PLANNING AND DEVELOPMENT SERVICES STAFF REPORT

**SUBJECT: Hampton Inn Planned Project Site Plan for City Council Approval
(2910 Jackson Avenue)
File No. SP13-002**

RE: Response to Planning
Commission Request

Project: Jackson Avenue –
Hampton Inn

LANDSCAPE PLAN

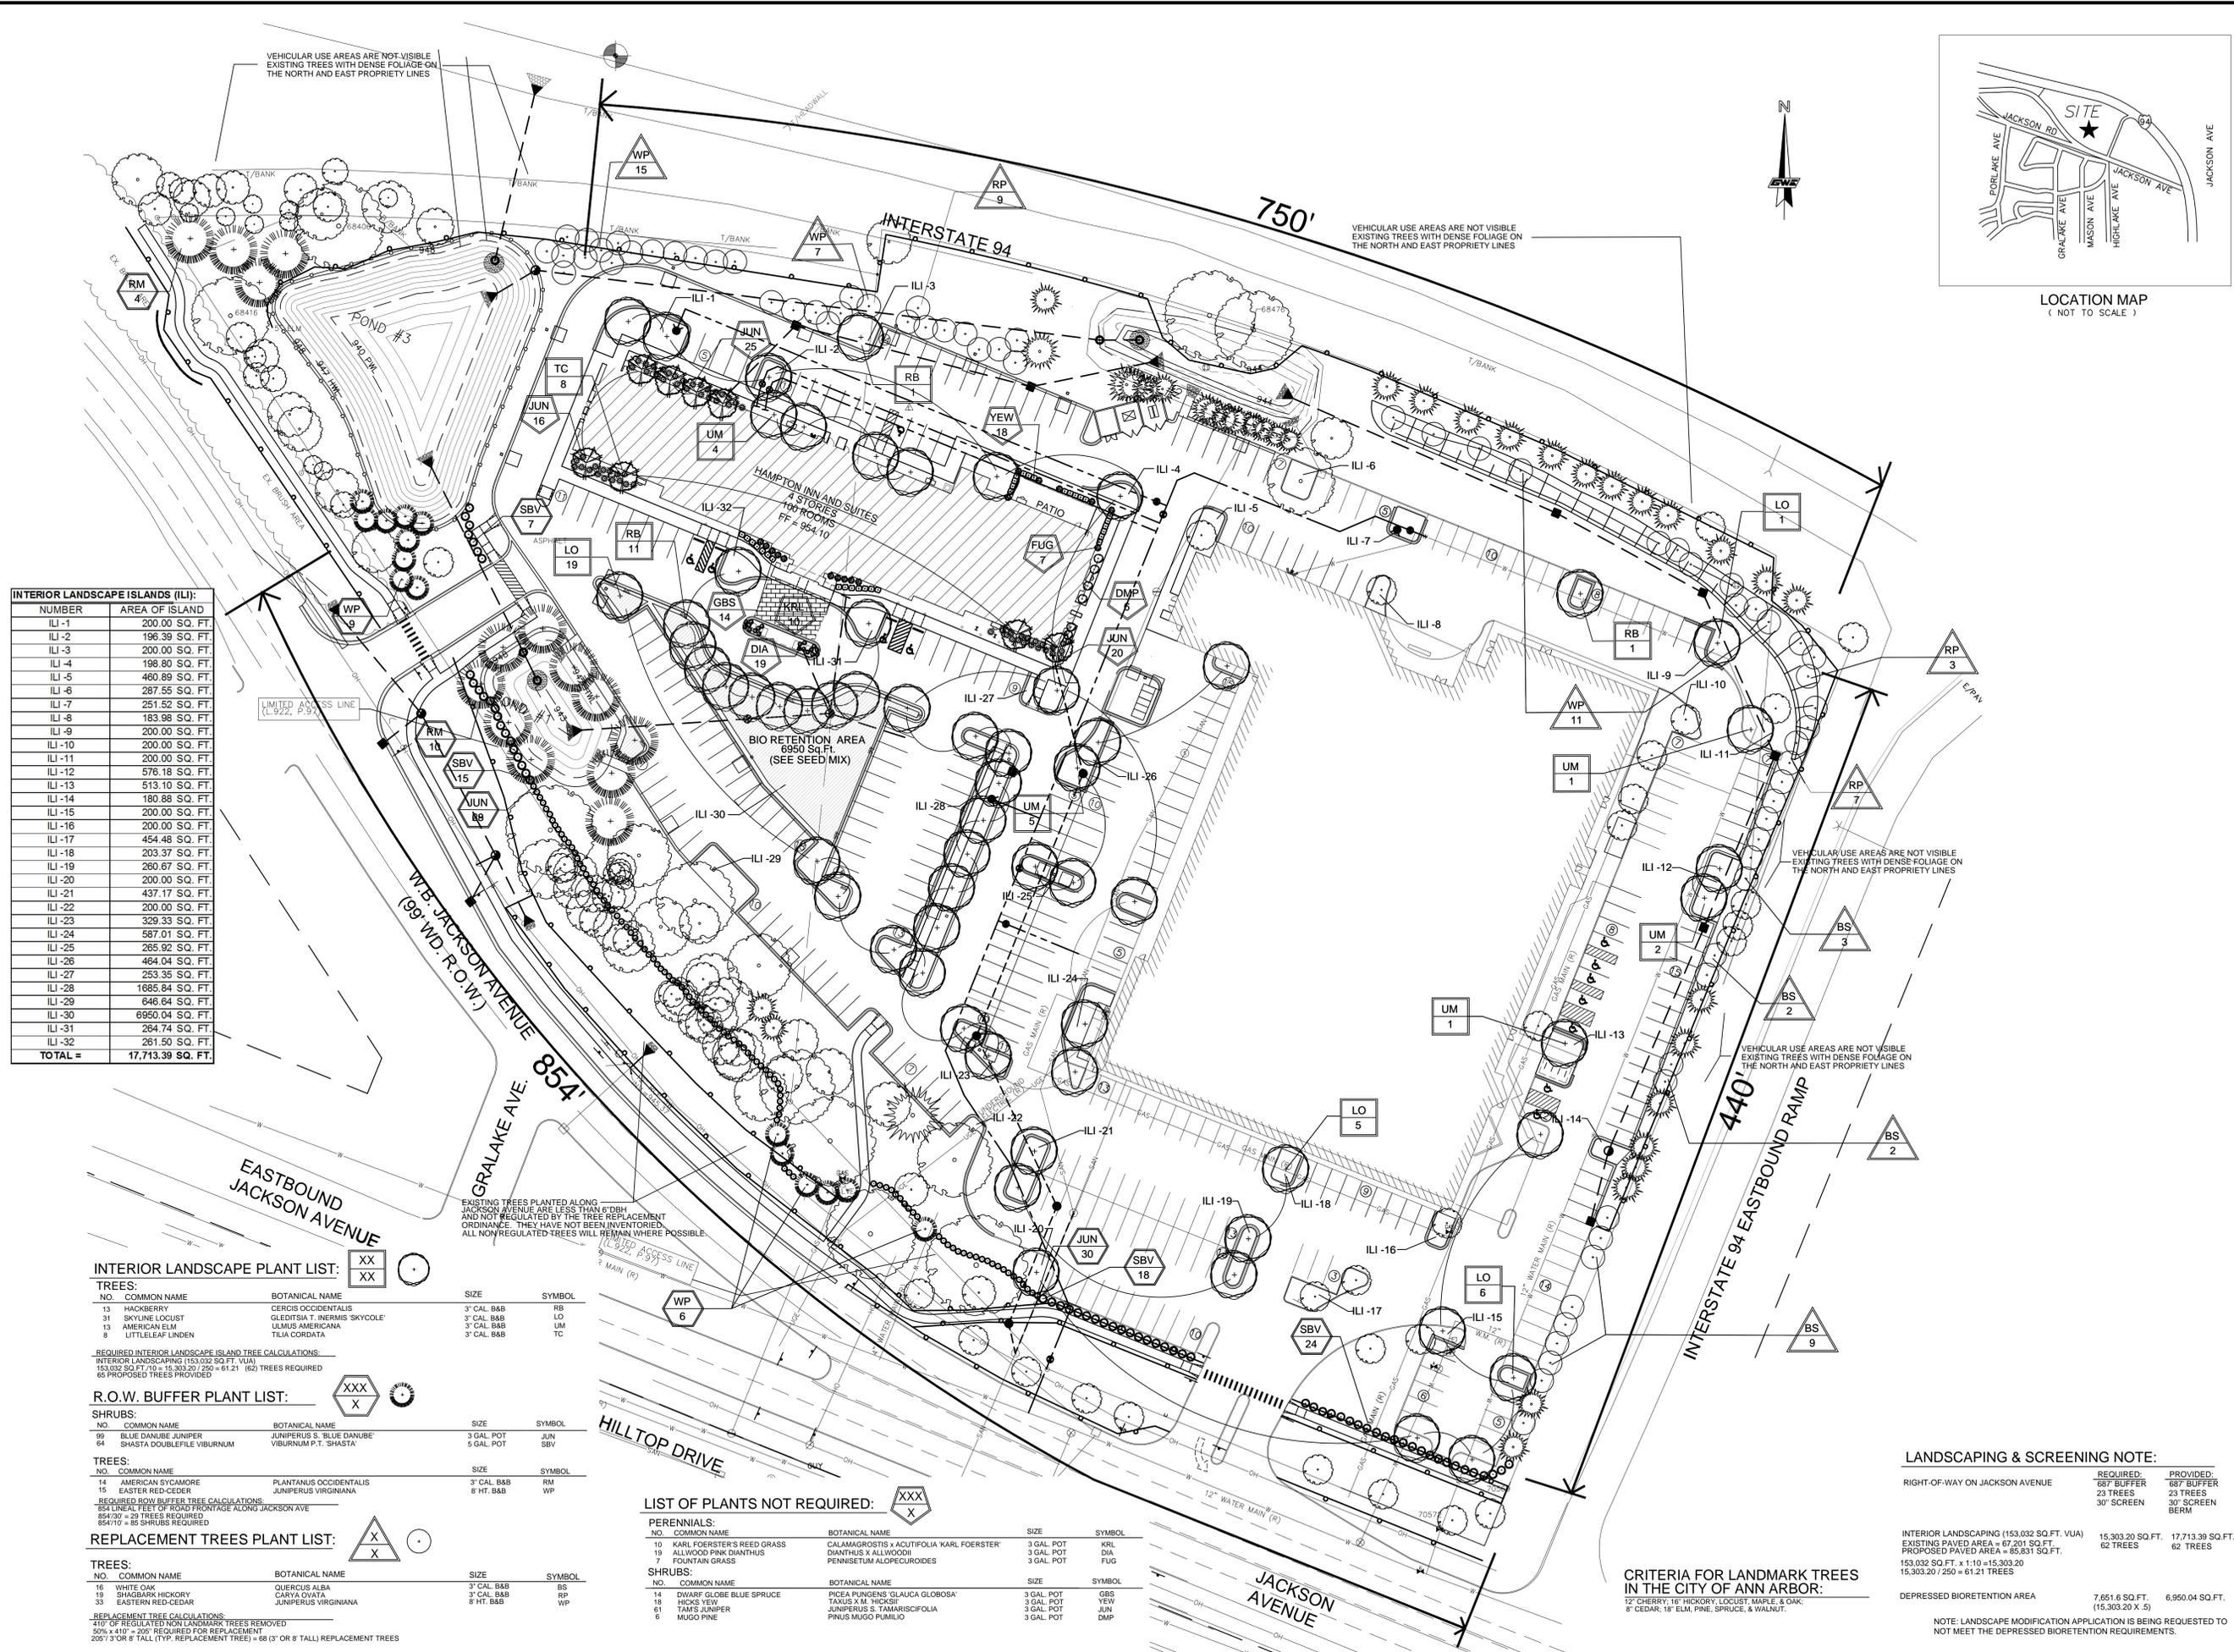
The petitioner has requested a modification of the requirement that when the total area required in interior landscape islands for all of the vehicular use areas on site exceeds 750 square feet, at least 50% of the required interior landscape area must be depressed bioretention areas and utilized for storm water management.

The area of the interior landscape islands is 17,713 square feet. The triangular bioretention area near the front door is 6,950 square feet, or 39% of the islands.

In order to reach the required 50% depressed bioretention area within the interior landscape islands, parking spaces would have to be removed or the depressed area would have to be split between multiple small areas. These multiple areas would prove difficult and inefficient to maintain. Furthermore, the large depressed open area is much more likely to take hold and be self-sustainable.

The most recent proposal has increased the overall green space on the site which in turn has increased the amount of landscaping for the project. While short of the required 50% depressed bio retention area, the site exceeds interior landscape square footage. Also, the landmark trees have been incorporated into the original design to reserve the natural beauty and history of the site.
